ADDENDUM NO. 3

Project Name: **JACKIE ROBINSON TRAINING COMPLEX VILLAS REMODEL (IRC-1914A)**

Bid Number: **2022009**

This addendum is released to provide answers to questions received to date, and to replace pages from the Plan Set as noted in "Attachments".

SHEET NO.
A-3
OF SIX

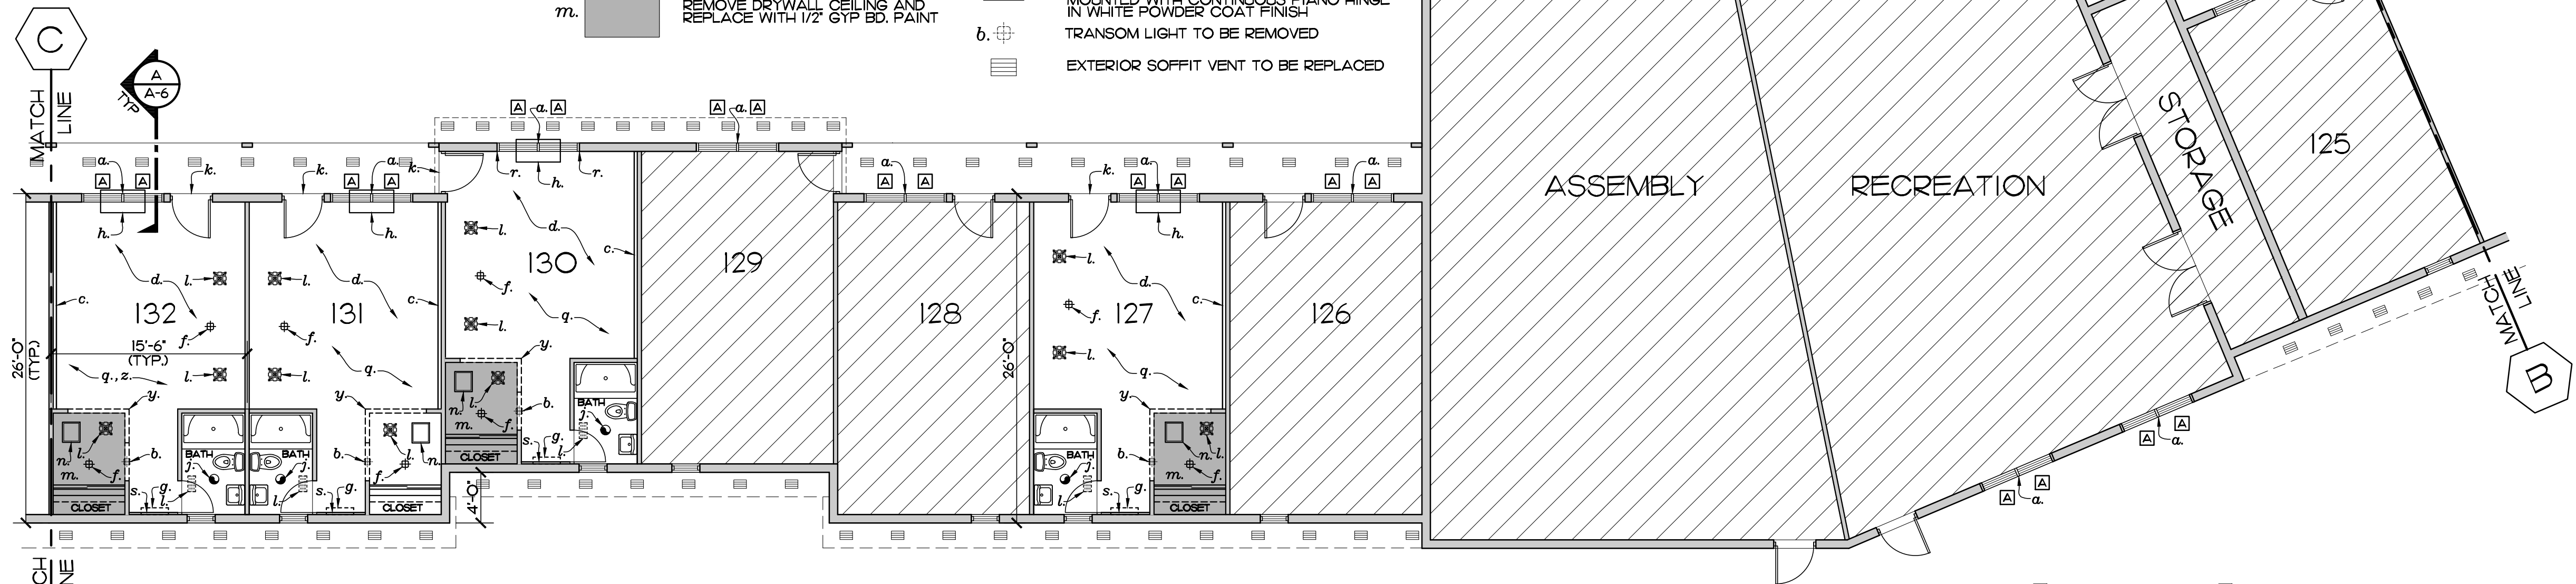
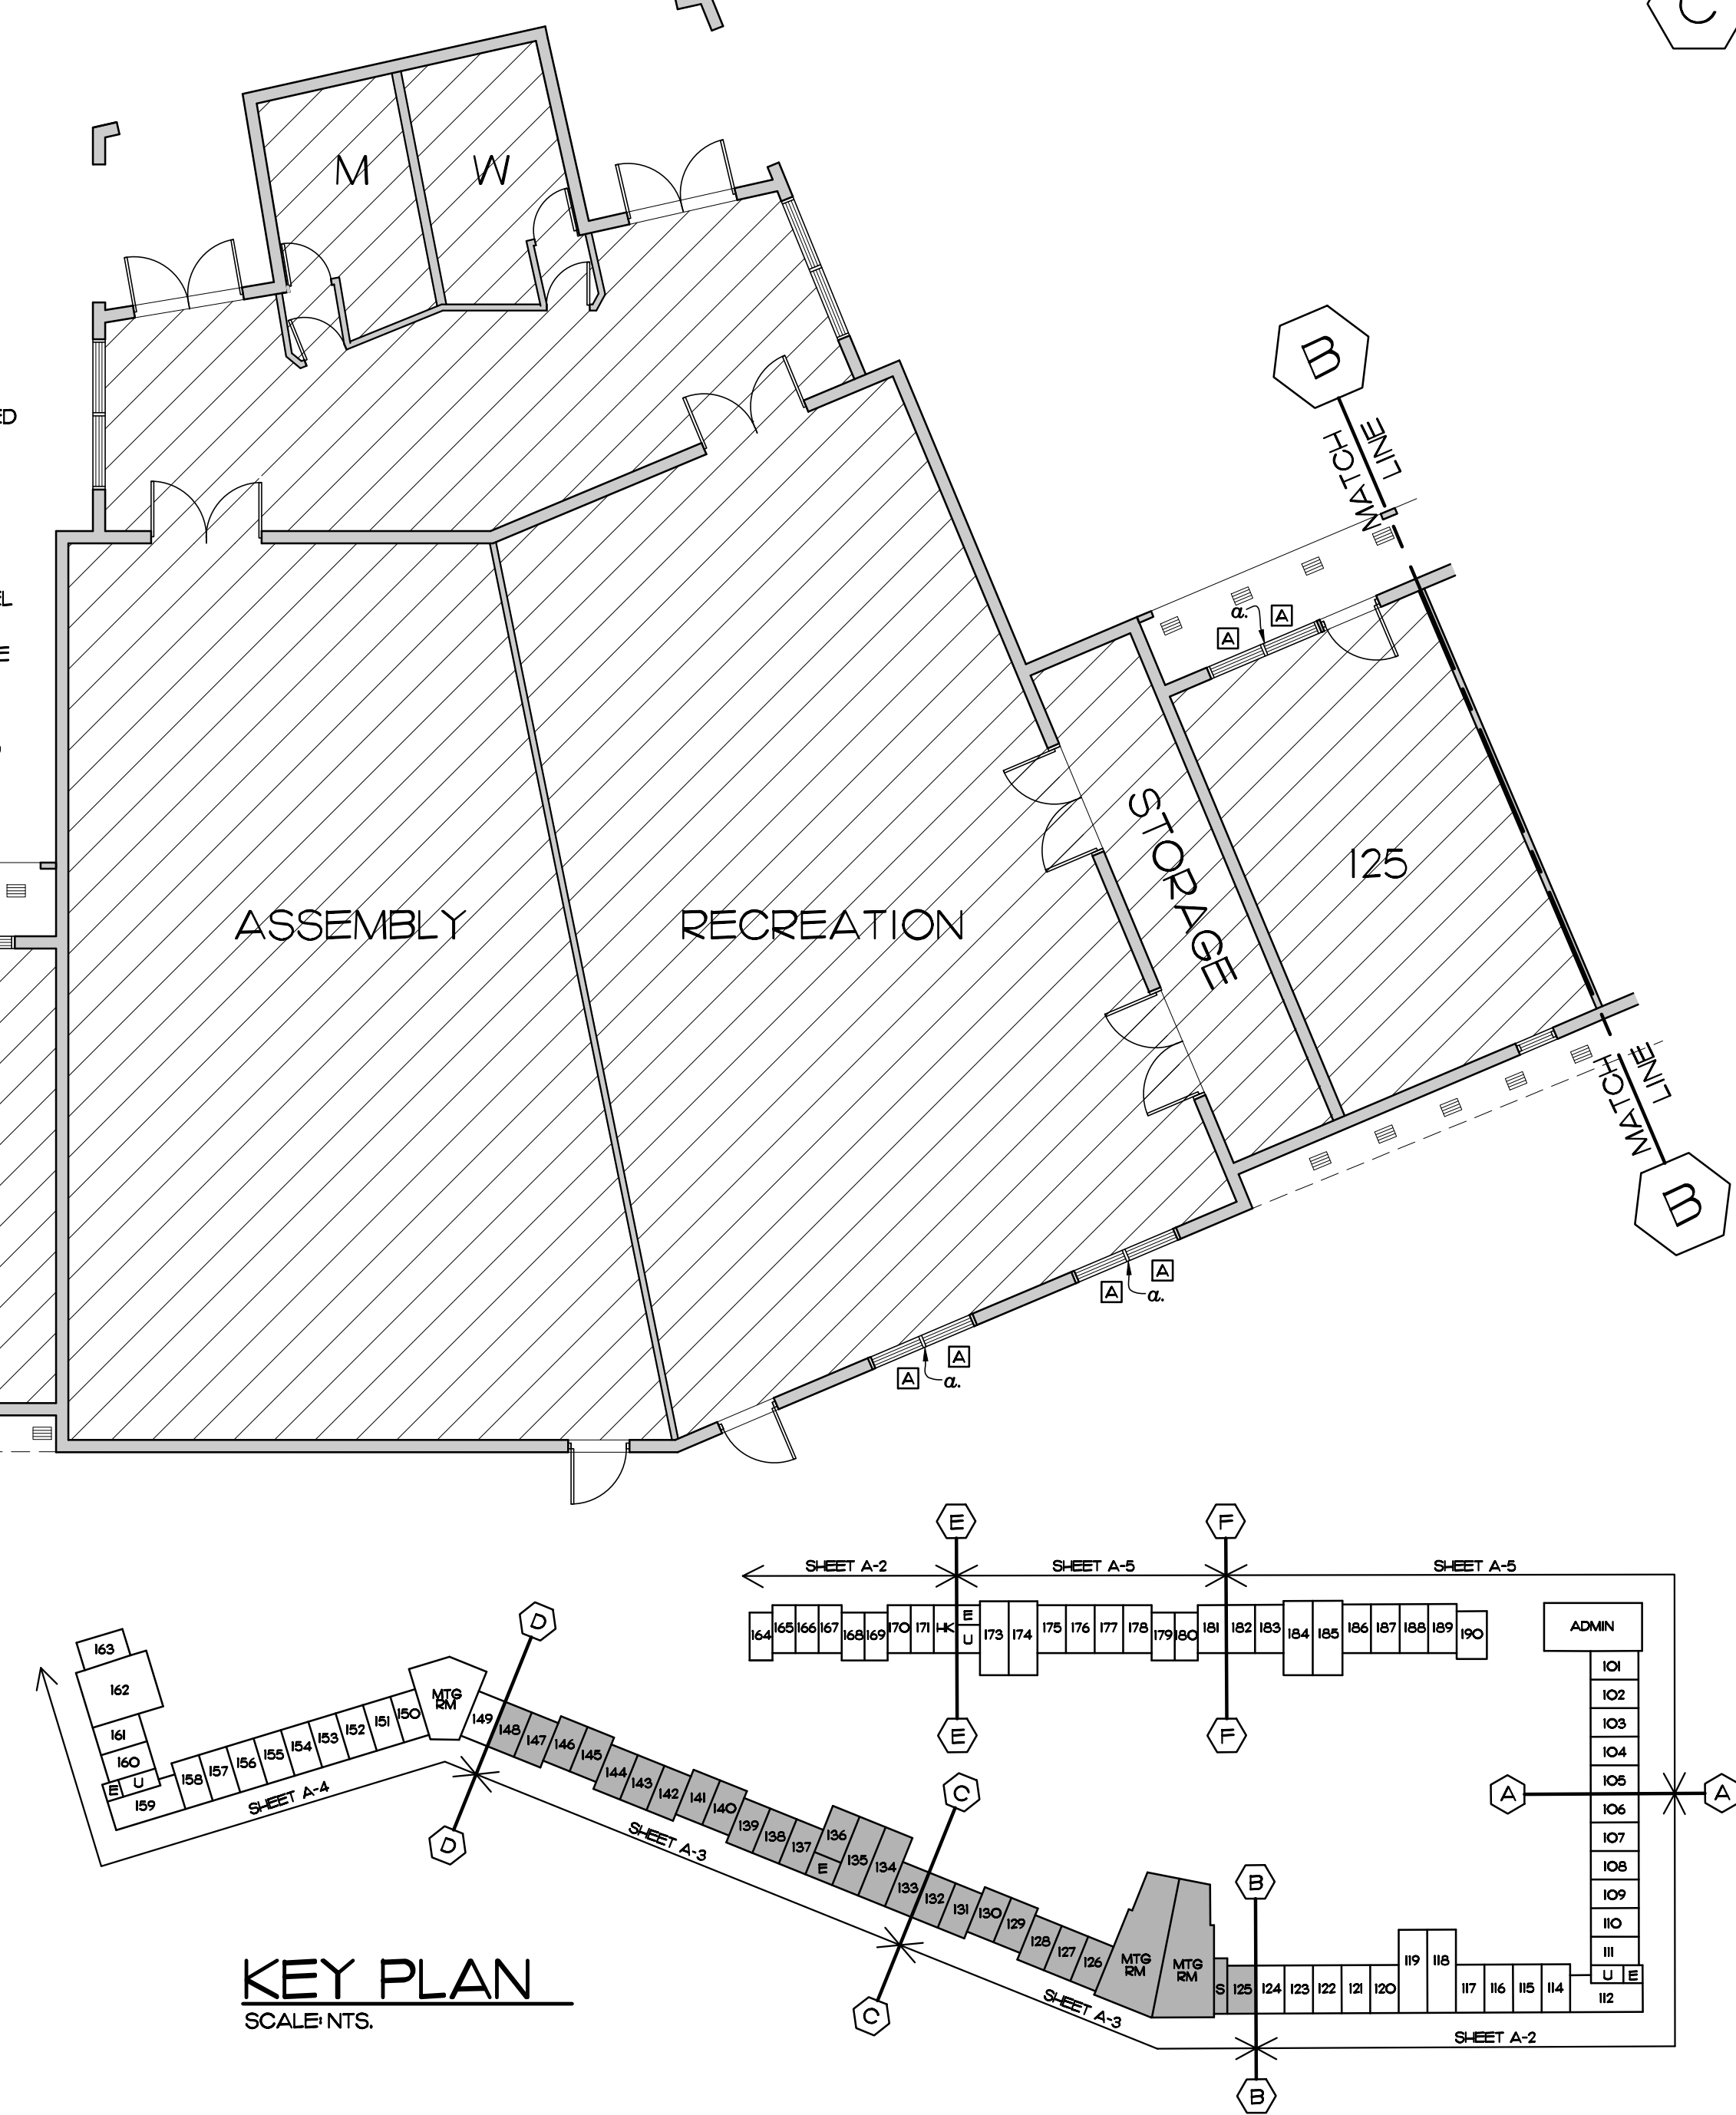
- Architectural plan sheets A-2 thru A-5: The bedroom windows in all of the suites are to remain. These were mis-labeled on plans to be replaced, therefore there will be no change in quantity.
- Sheet A-2 - Additional "r" call-outs have been added to room 107.
- Sheet A-4 – Shading has been added to Kitchen ceilings in rooms 150, 151, 153, and 154. Shading was also added to living room ceiling in room 161.
- Mechanical/Electrical Plans M-1 thru M-4; Trane PTAC unit specified in A/C Equipment schedule is no longer available and has been replaced with a GE PTAC unit, associated electrical notes have been revised.
- Itemized Bid Schedule; Item 1 expanded the description of Mobilization.
- Appendix C - Asbestos Survey Report: Page 4 of report under Drywall System (Texture) the word friable has been replaced with non-friable.
